Docket No. 52-021
MHI Ref: UAP-HF-11281

Subject: MHI's Second Responses to US-APWR DCD RAI No. 776-5851 Revision 3 (SRP 03.07.02)

Responses to Request for Additional Information No. 776-5851, Revision 3

US-APWR Design Certification

Figure 1 Depiction of Lindley-Yow Response Spectrum

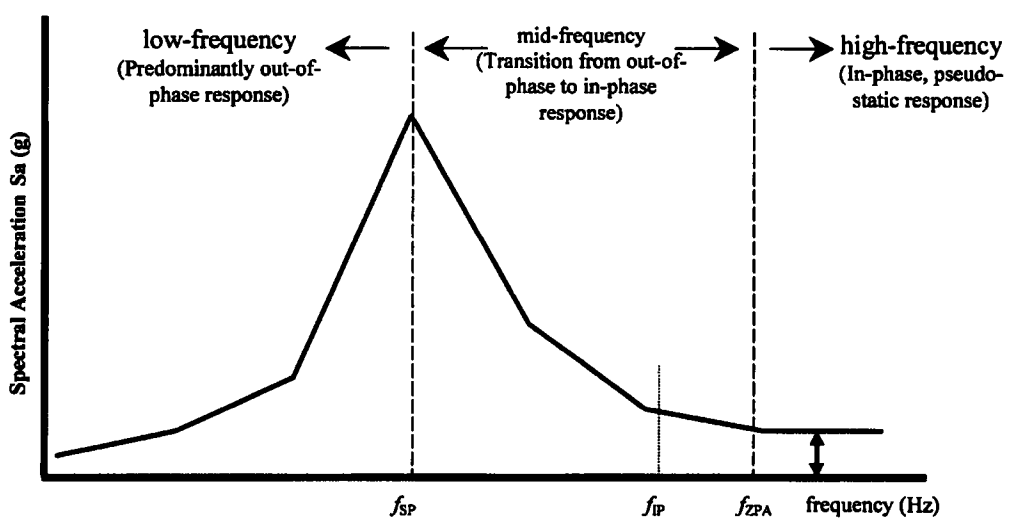
The staff noticed that so far the Applicant has not reported the use of the Lindley-Yow method for combining modal responses in the DCD (Rev. 3) and in seismic analyses reports of various category I structures and the Turbine building. The applicant is requested to discuss the unique circumstances and aspects of the A/B seismic analyses that require the use of Lindley-Yow method for combining modal responses. In RG. 1.92, one limitation on the use of Lindley-Yow's method is specified, "The Lindley-Yow's method should not be used for SSCs that have natural frequencies less than the frequency of the lowest-frequency spectral acceleration peak."

Thus, the applicant is requested to discuss the effect of the Lindley-Yow's method limitation on the seismic analyses responses. The Applicant is also requested to discuss how the periodic response component is combined with the rigid response portion and provide the technical basis and justification for the combination used.

The seismic response is calculated using the Lindley-Yow method described in NRC Regulatory Guide 1.92, and in NUREG/CR-6645. The Lindley-Yow method divides the total seismic response into two components: response in-phase with the ground motion and response out-of-phase with the ground motion.

A typical seismic response spectrum can be divided into three regions as shown in Figure 1 below. Defining f_{SP} as the frequency corresponding to the peak spectral value on the response spectrum curve and f_{ZPA} as the frequency corresponding to the zero-period ground acceleration (ZPA), the regions can be categorized as follows:

- Modes having a frequency less than f_{SP} (low-frequency range) are predominately out-of-phase with the ground motion and thus have no contribution to the in-phase response.
- For modes having a frequency between f_{SP} and f_{ZPA} (mid-frequency range), there are contributions to both the in-phase and out-of-phase responses.
- Modes having a frequency greater than f_{ZPA} (high-frequency range) are in-phase with the ground motion.

The total in-phase response is calculated by performing a static analysis in which the zero period ground acceleration (ZPA) is applied to the total in-phase mass. This procedure automatically accounts for the so-called "missing mass", or that portion of the structural mass that does not participate in the amplified modal responses.

The out-of-phase response is determined by performing a response spectrum analysis combining the response of modes having a frequency less than or equal to the frequency corresponding to the ZPA (f_{ZPA}). Modified spectral accelerations, $S'_{ai} = S_{ai}\sqrt{1-\alpha_i^2}$ are used in the analysis, where S_{ai} equals the unmodified spectral acceleration for mode "i". For modes which have a frequency less than f_{SP} (low-frequency range) and are predominately out-of-phase with the ground motion, $\alpha_i = 0$, which specifically addresses the limitation on the use of the Lindley-Yow method discussed in Regulatory Position C.1.3.2 of RG 1.92. For modes having a frequency between f_{SP} and f_{ZPA} (mid-frequency range), $\alpha_i = ZPA/S_{ai}$. Out-of-phase modal responses are summed using the Grouping method. The lowest dominant frequency of the AB structure in each direction (x,y and z direction) is greater than f_{SP}.

The total seismic response is calculated as the SRSS of the in-phase and out-of-phase components.
